BOARD ACTION REPORT – APPEALABLE ITEM

Project Name: 100 Gleason (2020-029)
Project Location: 100 Gleason Street
Request: Class II Site Plan Modification
Board: Site Plan Review and Appearance Board
Meeting Date: December 11, 2019
Board Vote: Approved on a 5-2 vote

TO: Site Plan Review and Appearance Board (SPRAB)
FROM: Anthea Gianniotis, Development Services Director
THROUGH: Scott Pape, Principal Planner
DATE: December 3, 2019
SUBJECT: Class II Site Plan Modification for 100 Gleason Street (2020-029)

SITE PLAN REVIEW AND APPEARANCE BOARD STAFF REPORT

East Elevation

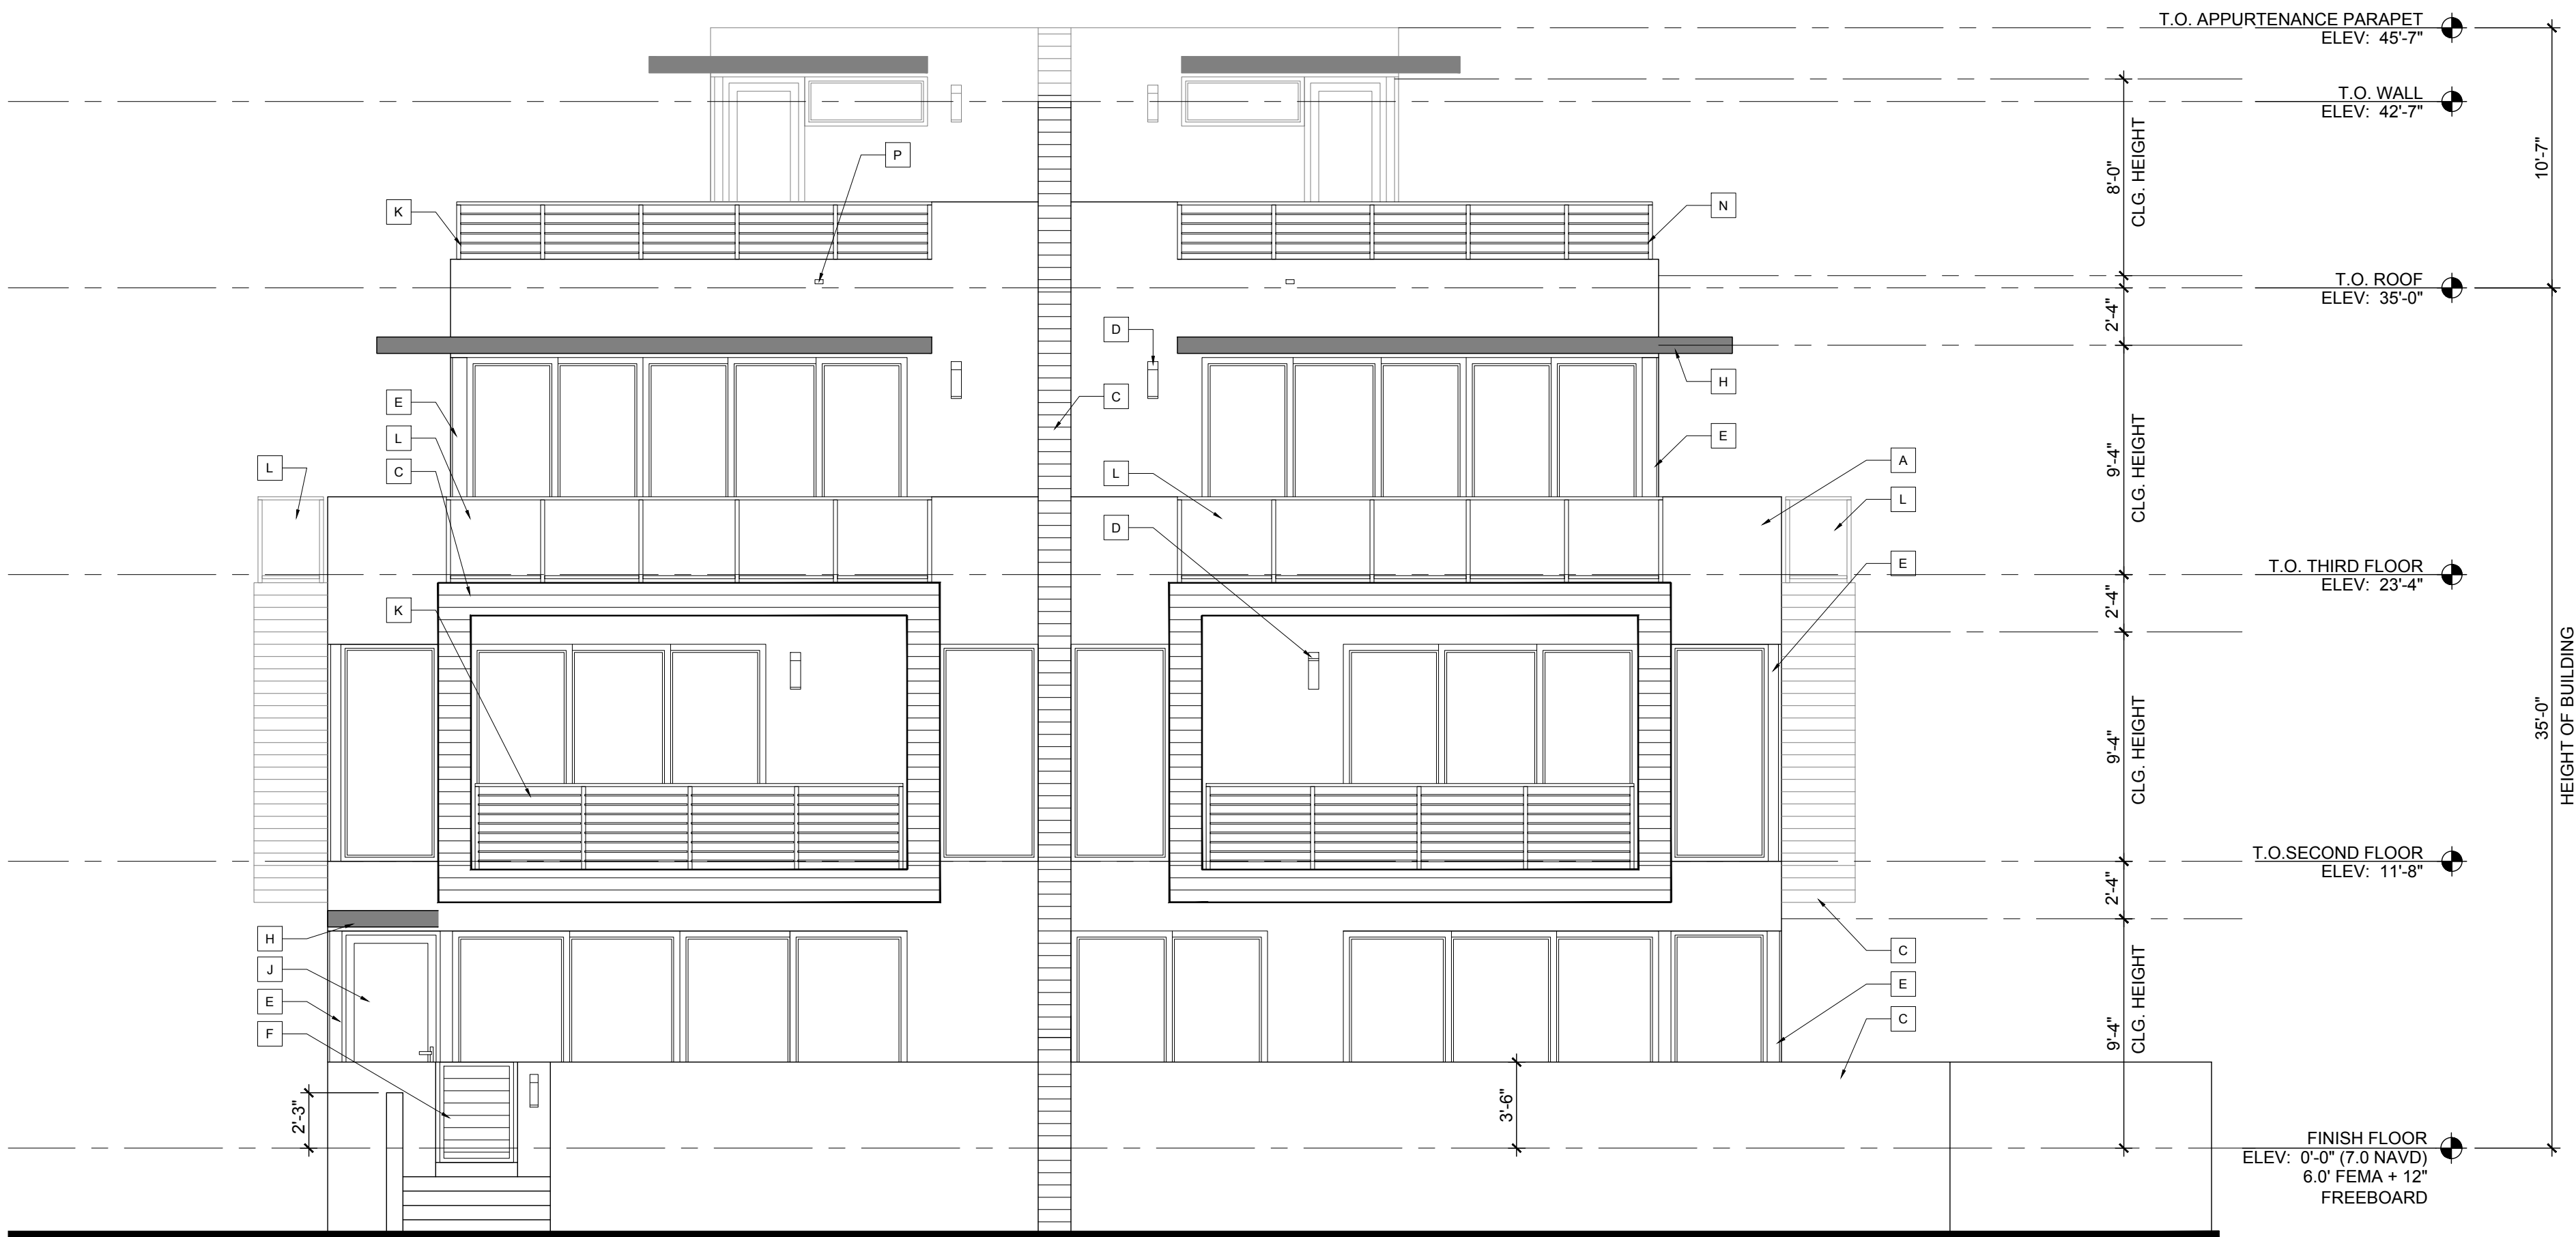
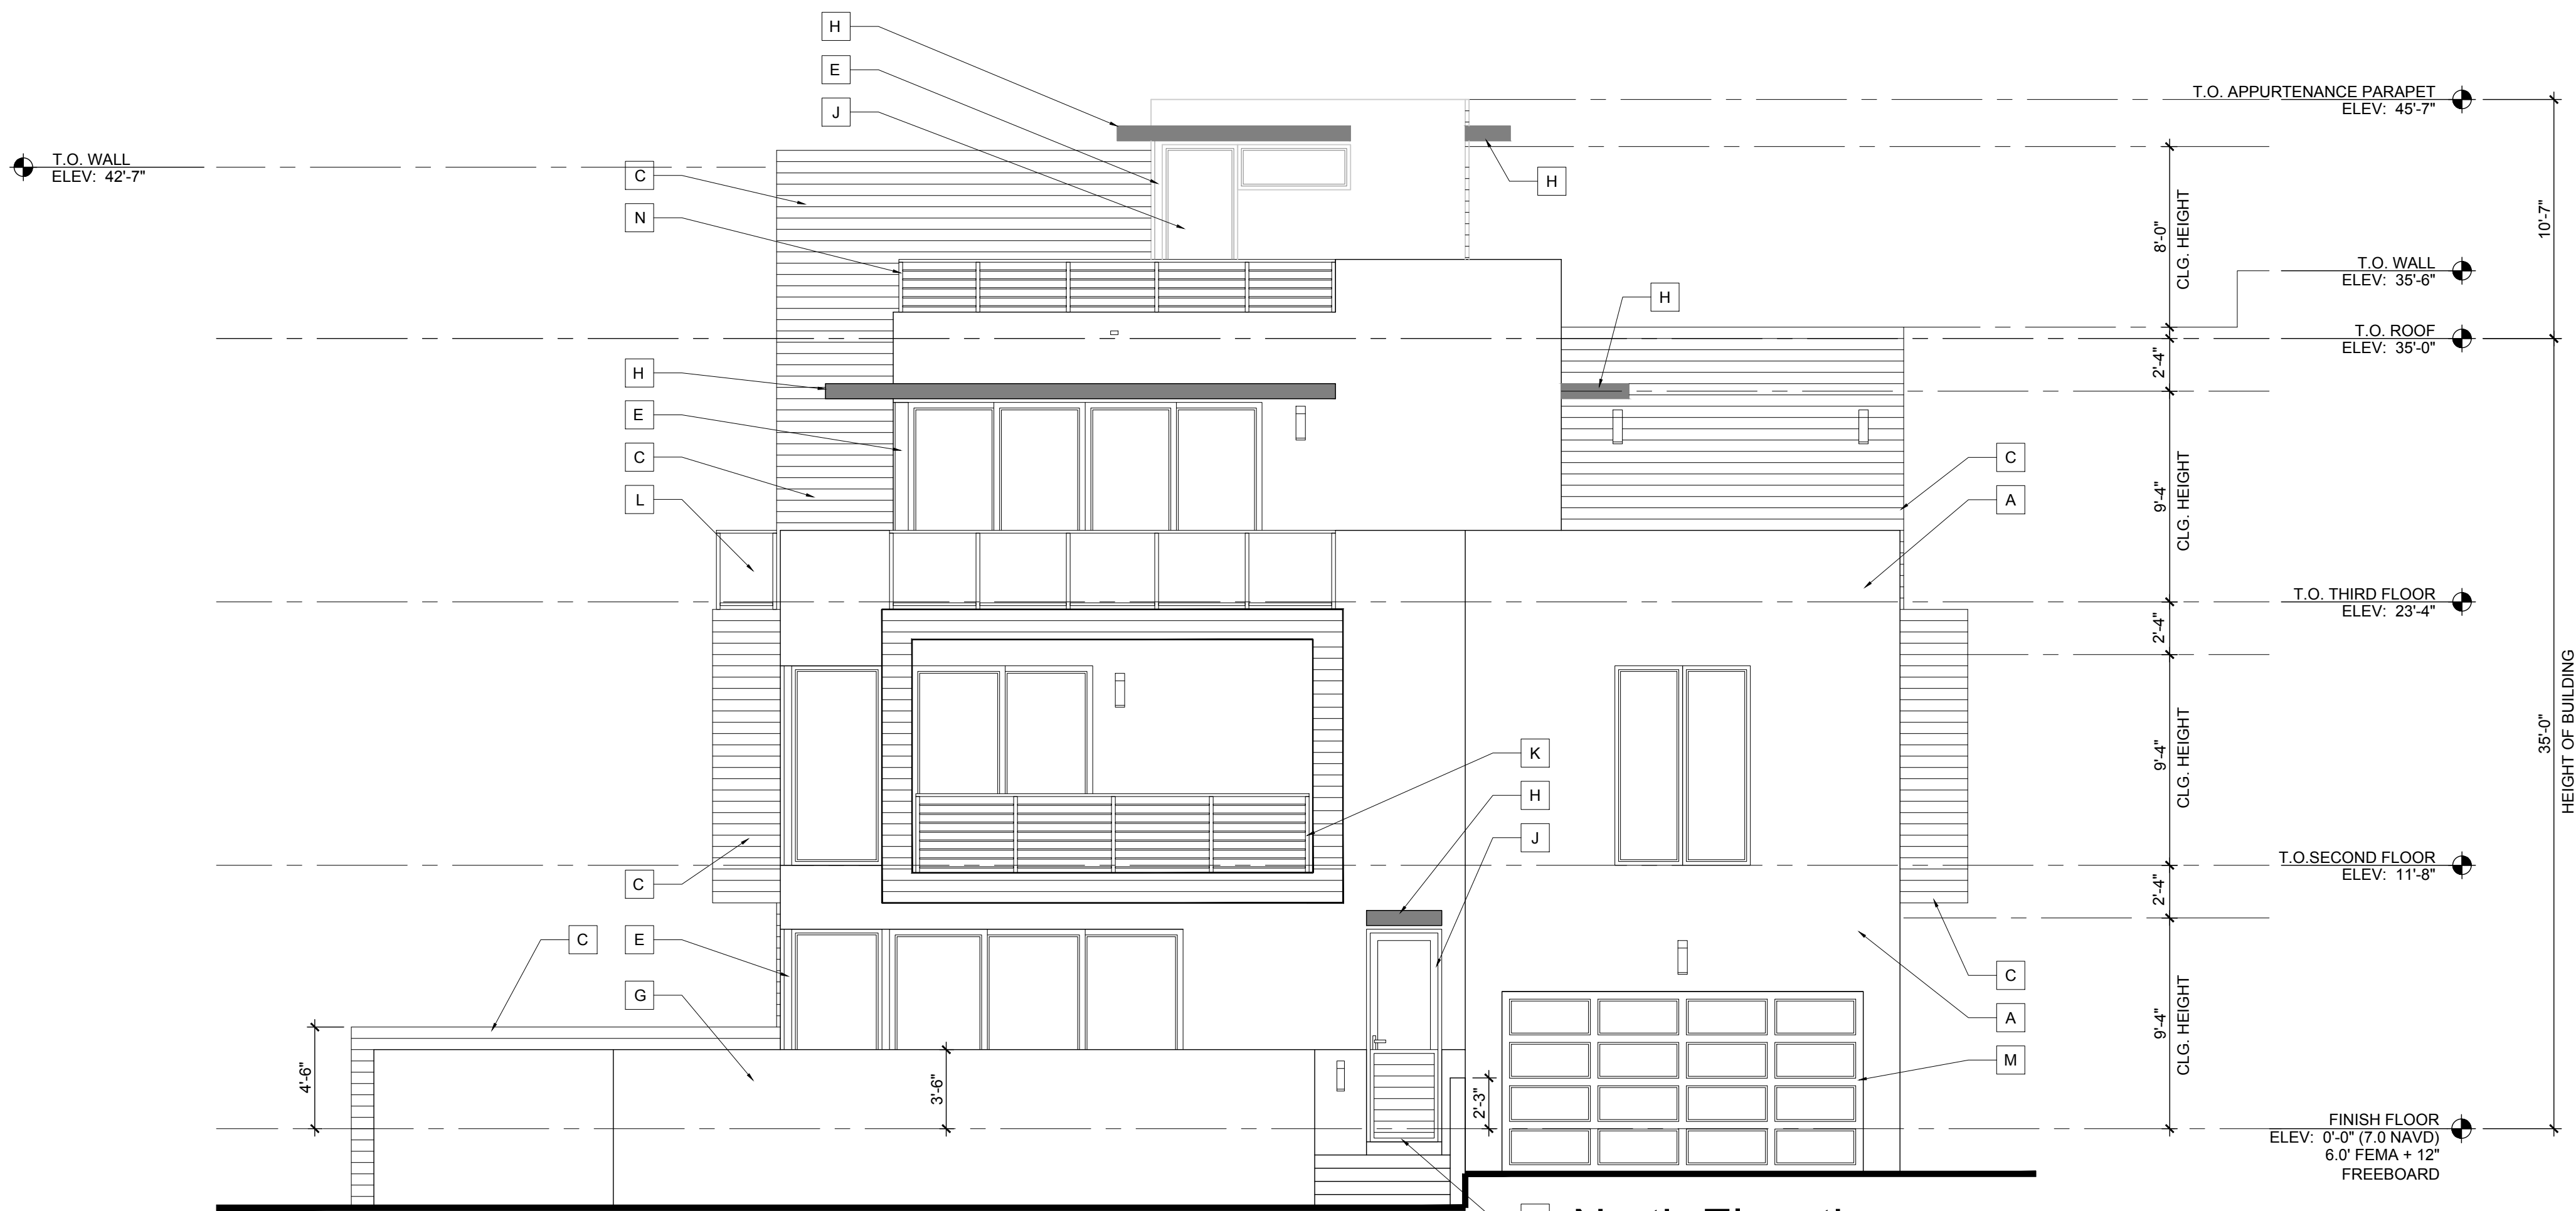
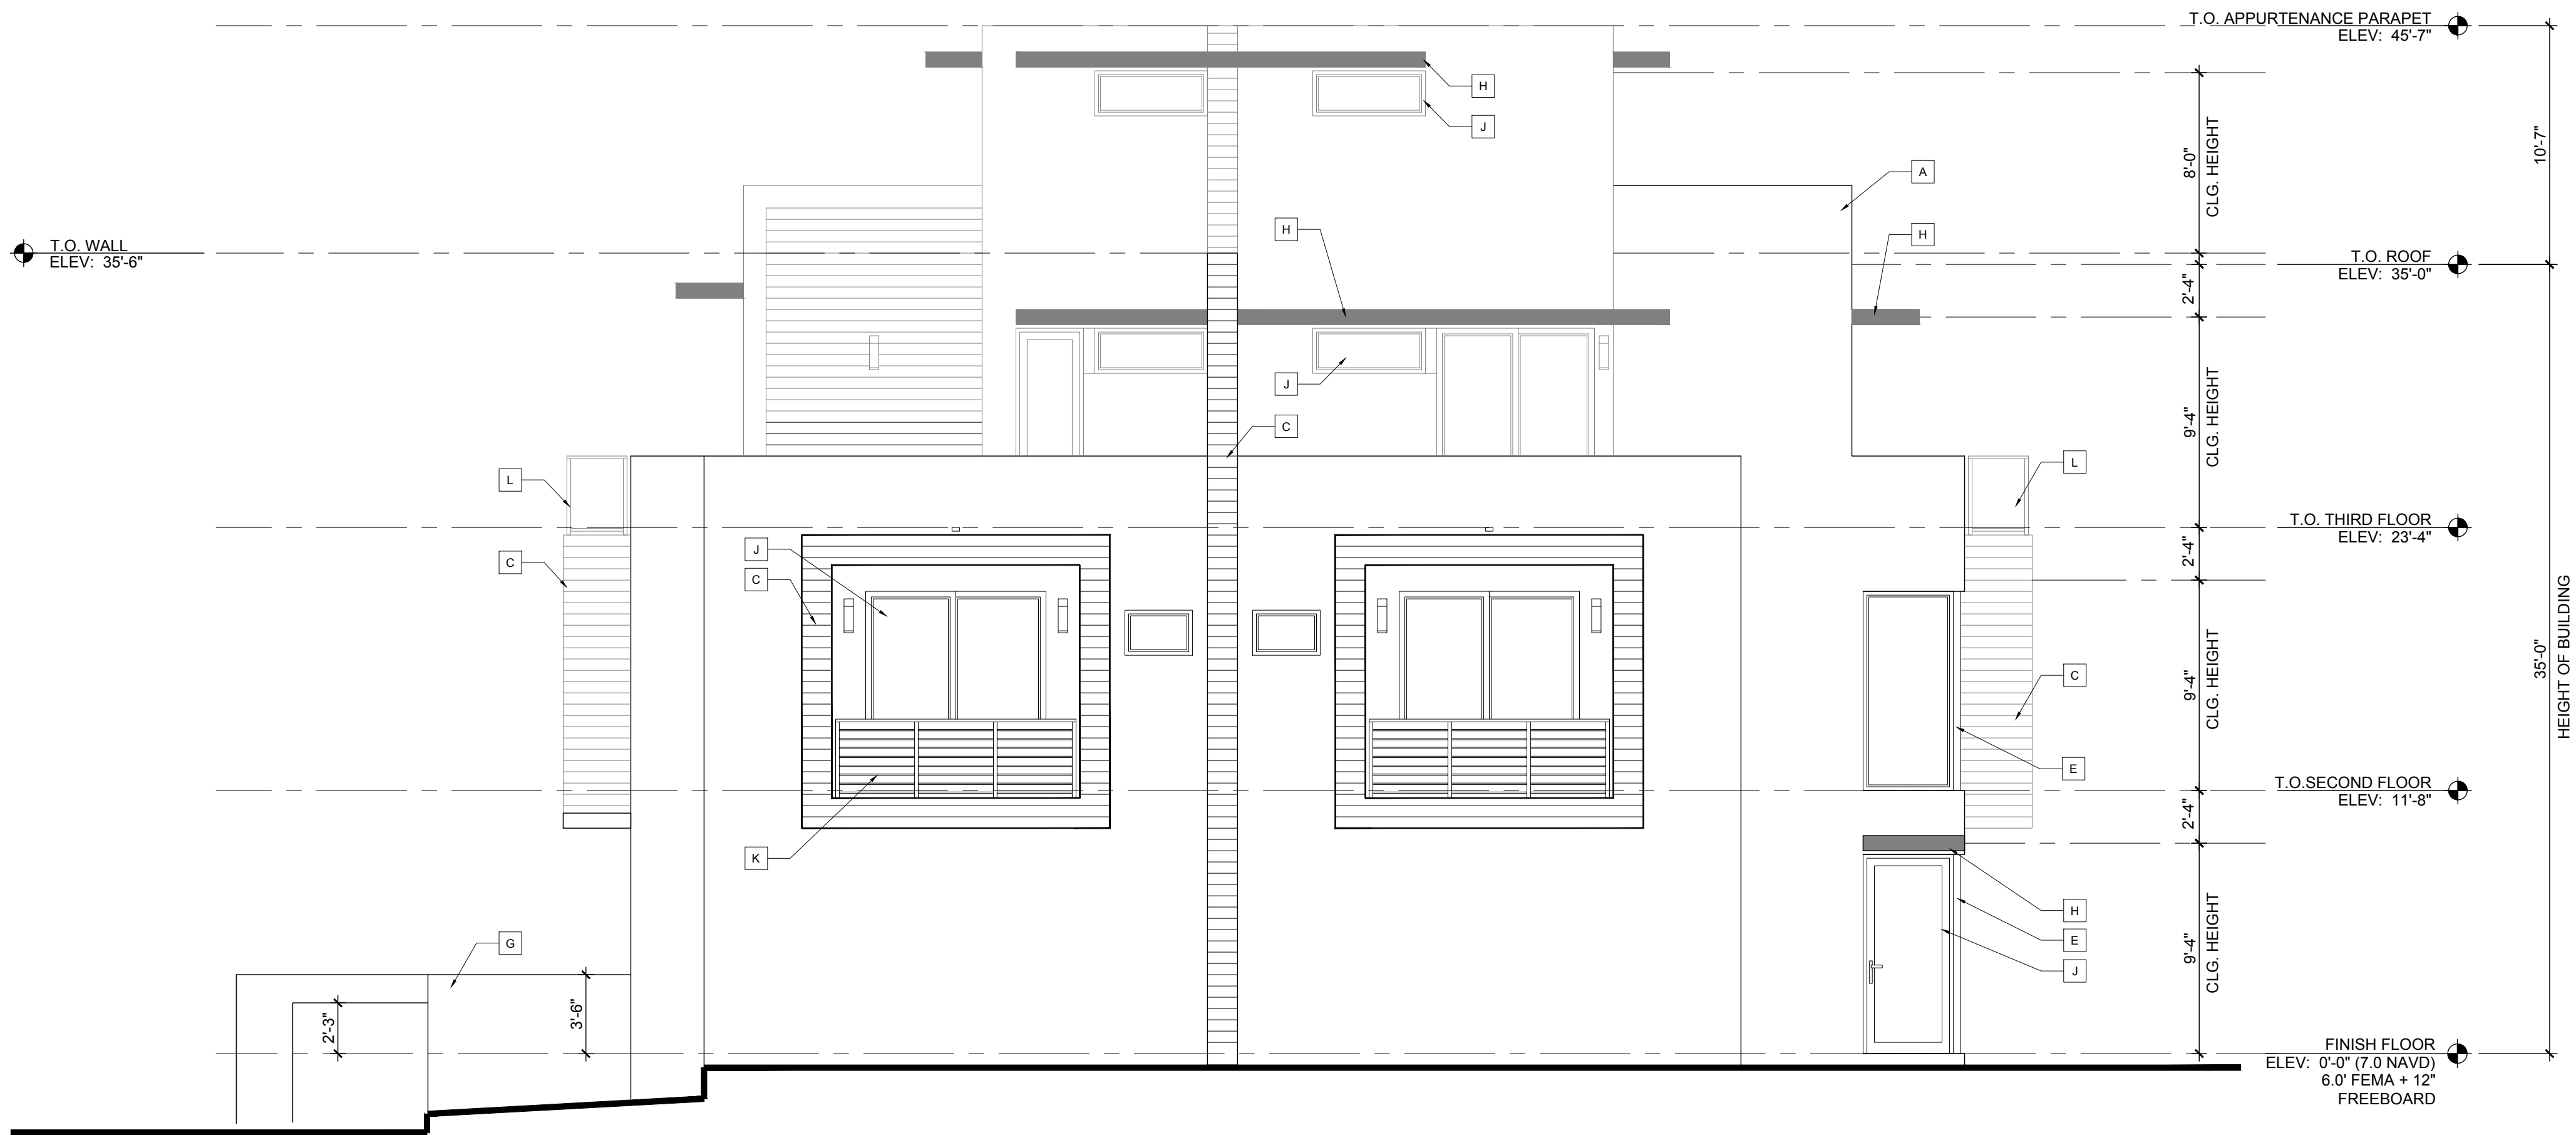
The Applicant has resubmitted plans that have the following changes in regard to the appurtenance.

- Appurtenance floor area reduced from 230 sf to 195 sf per unit.
- Appurtenance height reduced from 12 feet to 10 feet in height.
- Air Conditioner mechanicals relocated from within the appurtenance.
- Appurtenance setback increased by 4.25 feet along the western façade.
- Buttress stopped at the top of the Appurtenance roof parapet.
